| Device | XC886/888CLM Series |
| Marking/Step | AC |
| Package | PG-TQFP-48/64 |

This Errata Sheet describes the deviations from the current user documentation. The module oriented classification and numbering system uses an ascending sequence over several derivatives, including already solved deviations. So gaps inside this enumeration can occur.

Figure 2

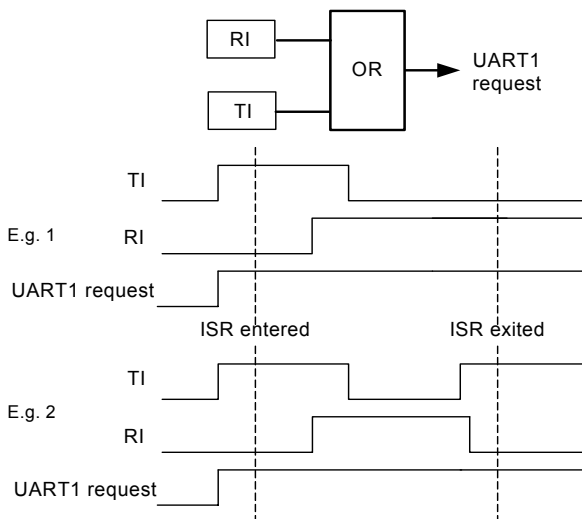
The problem is that it may occur at some point in the application, that any new UART1 interrupt request can no longer be detected after a return-from-interrupt (reti) due to service of earlier event(s). This happens when the following conditions are true:

1. UART1 events are serviced by interrupt (i.e. flags are checked and cleared only in the interrupt routine ISR),
2. Either RI or TI is set at any one time throughout the ISR (even while the other is cleared) such that at least one of the flags is still set after reti, causing the UART1 request line, which is an OR-function of the two flags RI and TI, to remain set throughout the ISR and after reti.

Two example scenerios are illustrated in the following figure:

This means, any future UART1 RI or TI event is not able to cause a rising edge and therefore not able to trigger an interrupt request to the core – as if the UART1 interrupts had been disabled, until both RI and TI flags are cleared at some time. The clearing of flags would have to be done by user's code

There are two suggested workaround:

1. If other events of interrupt node XINTR8 (EX2) need not be enabled for interrupt, disable this interrupt node and use software polling of the flags instead.
2. Before return from interrupt, check again if RI or TI is (still) set (due to new request since the last check). If so, jump and execute the ISR routine from start. Exit only when all flags are checked to be cleared. However, dummy interrupt of the node may occur after return from interrupt, and should be ignored. Another drawback is if UART1 events are occurring at high rate, the CPU may be 'stuck' in the service routine of the UART1 interrupt for a long time.

Figure 4 FIFO structure

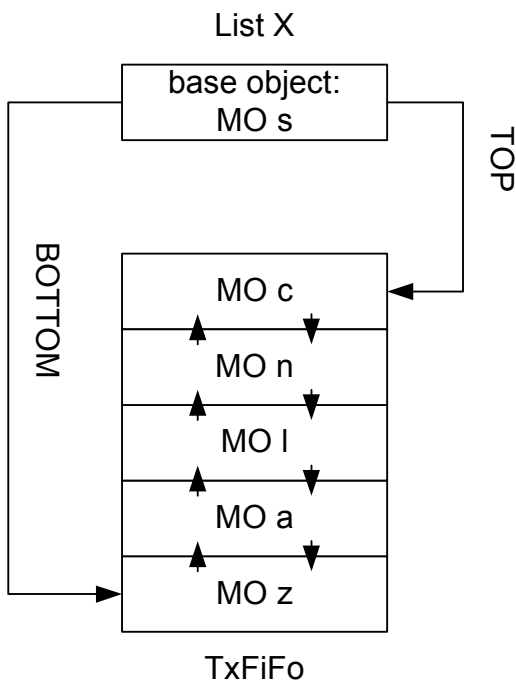
Real behaviour

A Tx FIFO overflow interrupt will not be generated after the transmission of the Tx FIFO base object.

Workaround

If Tx FIFO overflow interrupt needed, take the FIFO base object out of the circular list of the Tx message objects. That is to say, just use the FIFO base object for FIFO control, but not to store a Tx message.

Figure 6 Counting sequence of T12 in center-aligned mode

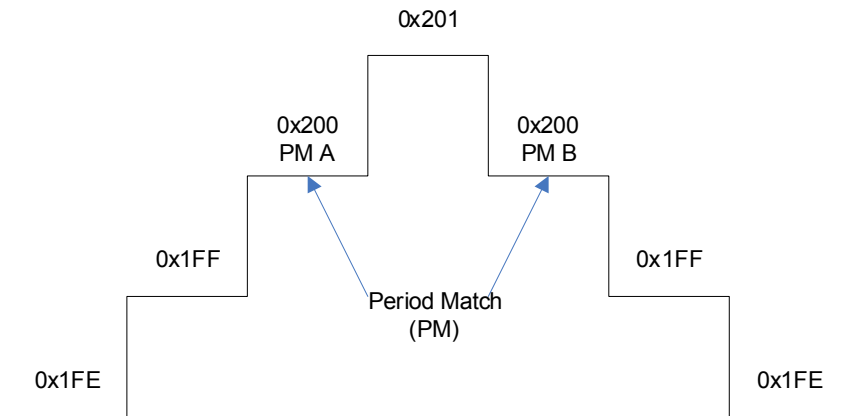
After detecting a period match (PM A) in centre-aligned mode, T12 counts down from PM + 1 as shown below:

This means a second PM event (PM B) will occur during the counting down. If ADC is triggered externally via ETRx2 (T12PM), it will be triggered twice in succession. Depending on how real-time the application code is running as well as the T12 count rate and ADC conversion rate, the application could observe two ADC interrupts - once at PM A and once at PM B.

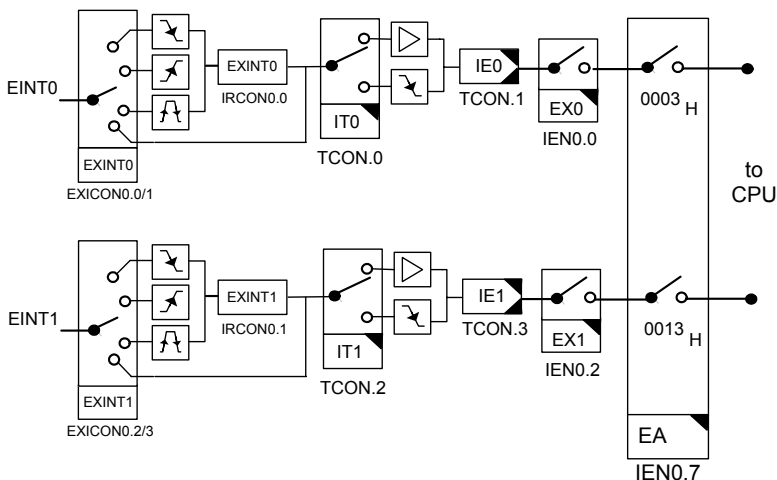
For the 24-KByte Flash variant, writing to the unavailable program memory addresses from 5000_H to 5FFF_H can lead to corruption of existing data in the valid P-Flash addresses from 4000_H to 4FFF_H.

The user has to make sure not to write to the addresses from 5000_H to 5FFF_H.

Figure 8

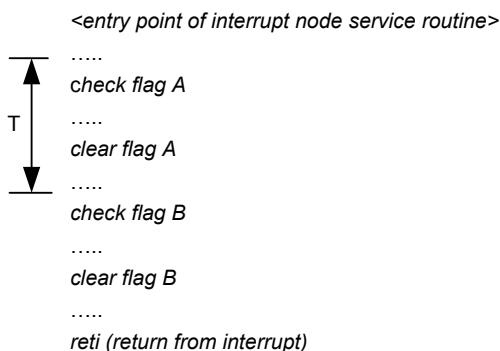
It might occur in the application, that sometimes NMI interrupt requests are serviced, but no active NMI interrupt flags are found.

Consider the following NMI interrupt service routine pseudo-code, and scenario where a NMI interrupt source A event leads to interrupt request of the NMI node and CPU vectors to the NMI interrupt routine. Meanwhile, NMI interrupt source B and its flag becomes active any time in the duration indicated by T:

In this case, NMI flag B will be cleared as a standard procedure by the NMI interrupt routine in the current service. However, the pending interrupt request for the NMI node remains activated after RETI, as it is only cleared by hardware when CPU acknowledge the NMI interrupt and vectors to the NMI service routine.

Figure 9

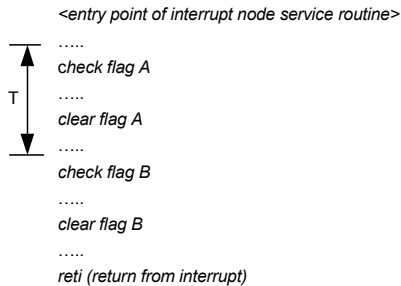
Consider the case where an enabled interrupt node is shared by more than 2 events, and where at least two of the events (A and B) are enabled for interrupt while at least one event (C) is not enabled for interrupt. In this case, flag C is one of the flags listed in above table.

While the interrupt routine is already running due to event A having occurred, event B and C occurs any time in the duration indicated by T:

This sets the pending interrupt request while flag B is set. Although event B is serviced and flag B is cleared in the following service routine, on return from interrupt, the pending interrupt request remains activated. This is because event C is not enabled for interrupt (and therefore flag C is neither checked nor cleared in the interrupt routine) while flag C is not qualified. This leads to following servicing of the interrupt node again, but potentially no active flag is found, i.e. dummy interrupt service. To prevent such dummy interrupt vectoring on the above listed interrupt nodes, do not use mixed interrupt servicing and polling scheme, i.e. enable all events of the node for interrupt if interrupt node is enabled. Otherwise if mixed interrupt servicing and polling scheme is to be used, ignore these dummy interrupt vectoring.

Figure 10 Loss of Arbitration

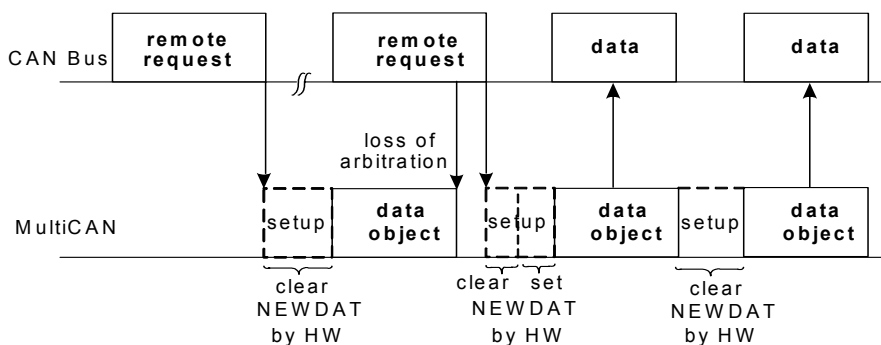
When the appropriate message object (data frame) triggered by the first remote frame wins the arbitration, it will be sent out and NEWDAT is not reset. This leads to an additional data frame, that will be sent by this message object (clearing NEWDAT).

There will, however, not be more data frames than there are corresponding remote requests.
